Office Action Summary

09/980,659

SAKAMOTO ET AL. *an*

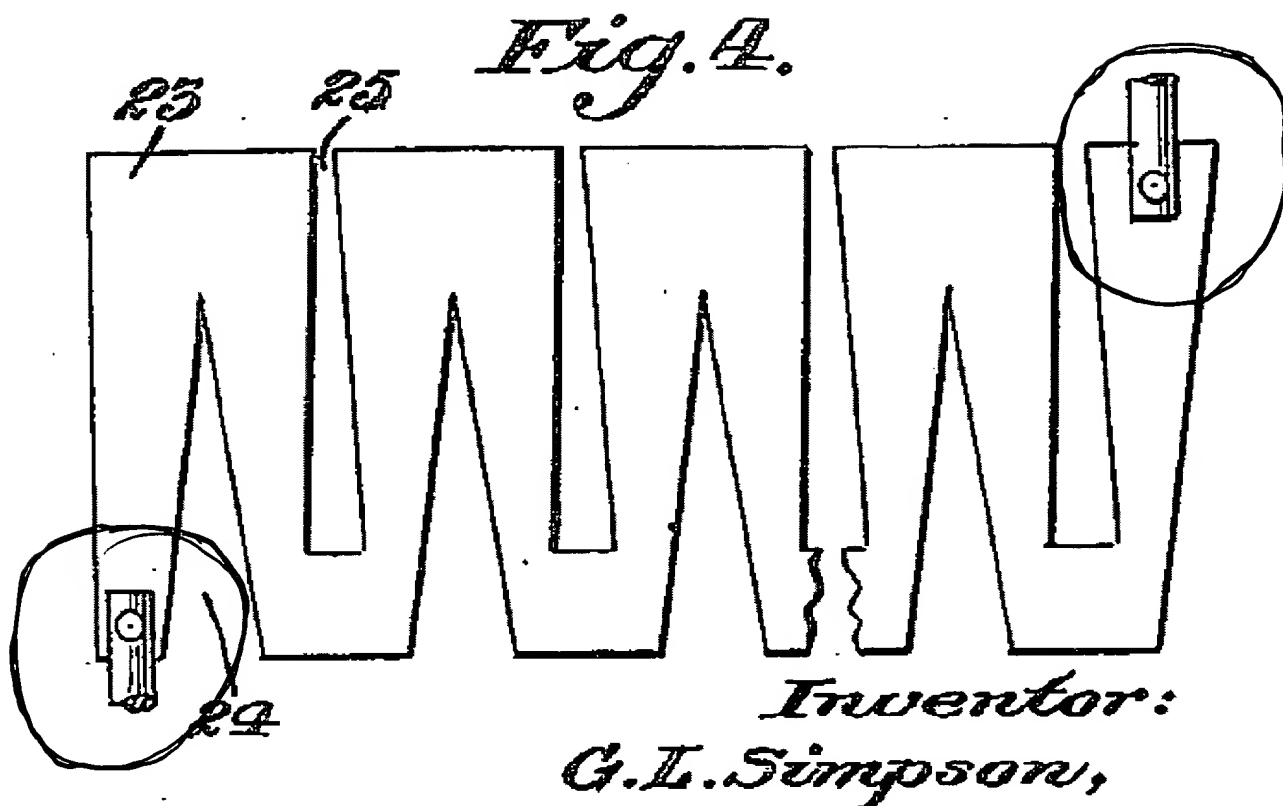
Claim 2 is rejected under 35 U.S.C. 103(a) as being unpatentable over Perrett (US 5,415,724) in view of Bohener (US 2,464,633) and further in view of Simpson (US 1,975,410). The claim differs from the previously cited prior art in calling for asymmetrical electrode portions. But asymmetrical electrode portions in electric heaters is well known in the art. Simpson (US 1,975,410), for example, discloses providing electrode portions for a serpentine electric heater 25 with unequally sized electrode portions. Compare the left electrode portion with the right electrode portion in Fig. 4 of Simpson (US 1,975,410), reproduced below for clarity:

Such an arrangement produces a non-uniform heating profile along the heater thus compensating for temperature non-uniformities during operation. See Page 2, lines 26-48. In view of Simpson (US 1,975,410), it would have been obvious to one of ordinary skill in the art to provide unequally sized electrode portions in the heater of the previously described apparatus to produce a non-uniform heating profile along the heater thus compensating for temperature non-uniformities during operation.
